Submission of Further Information (FI)

Temporary Shop and Services (Retail Shop for Hardware Groceries and Construction Materials) with Ancillary Facilities for a Period of 5 Years in “Residential (Group D)” Zone, Lots 681 RP (Part), 682 RP (Part) and 683 RP (Part) in D.D. 106 and Adjoining Government Land, Yuen Long, New Territories (Application No. A/YL-KTS/1102)

Further Information for Planning Application No. A/YL-KTS/1102**Response-to-Comments****Comments from Drainage Services Department**

Plan 5.1a
 (P 22068B)

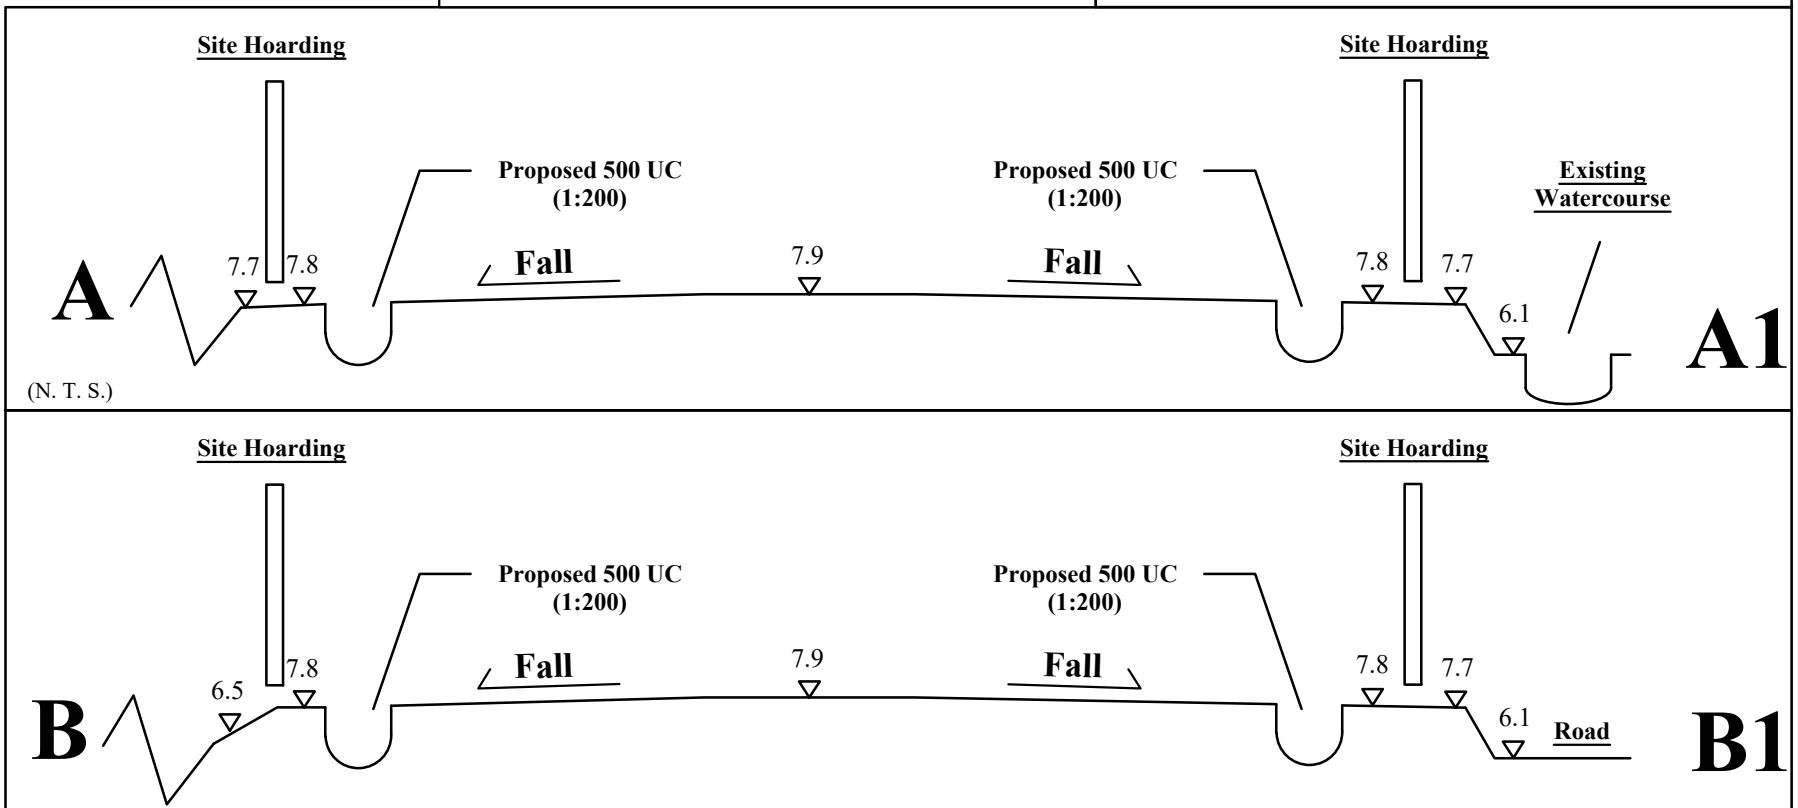
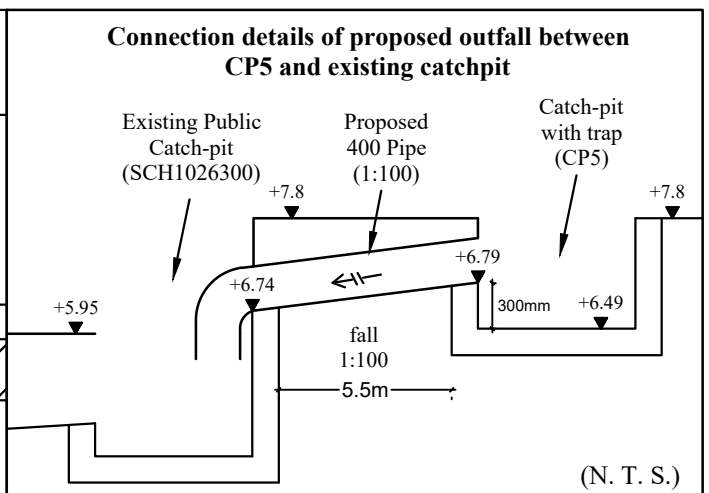
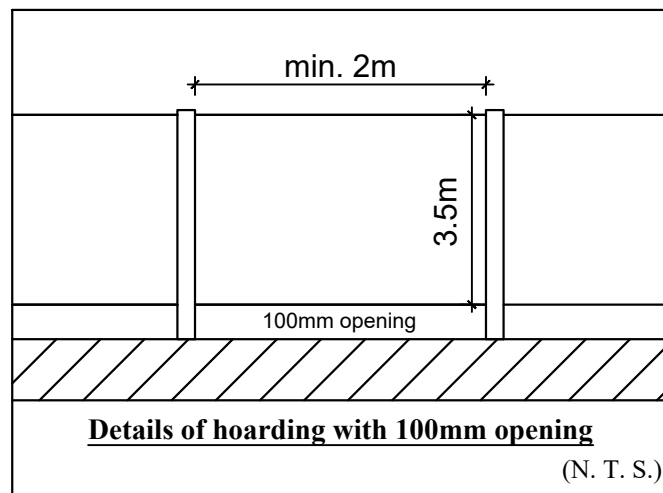
I.	Comments	Responses
1.	Please provide peripheral surface channels at the entrance of the site (the northwest side of the application site) to collect the surface runoff accrued on the application site and to intercept the overland flow from the adjacent lands.	Provided. Please refer to Plan 5.1a.

2.	Please indicate the feature number of the existing public catchpit, to which the applicant proposed to discharge the stormwater from the subject site on the drainage plan for clarity. Please also advise whether the existing DSD's drainage facilities (SCH1026300, SGJ1038727 and SGJ1038728, etc.) will be maintained/affected due to the proposed development. Please clearly indicate the above on the drainage plan for reference. Besides, the applicant should check and ensure the hydraulic capacity of the existing drainage facilities would not be adversely affected by the captioned development.	Noted. The existing DSD's drainage facilities (SCH1026300, SGJ1038727 and SGJ1038728, etc.) will be maintained due to the proposed development. The above is indicated on Plan 5.1a.

3.	It is noted that the proposed 400mm pipe connecting from CP3 to the existing public catchpit is quite steep with a gradient of 1:4. Please review the gradient of the proposed drainage system and check the velocity of the flow for such proposed drainage facility for further comments.	The gradient and the invert level is reviewed. Please refer to Plan 5.1a.

5.	The details of the opening (100mm opening) for the proposed hoarding should be indicated on the drainage plan (Plan 5.1) for clarity.	Noted. Please refer to Plan 5.1a.

Note: The existing DSD's drainage facilities (SCH1026300, SGJ1038727 and SGJ1038728, etc.) will be maintained due to the proposed development.
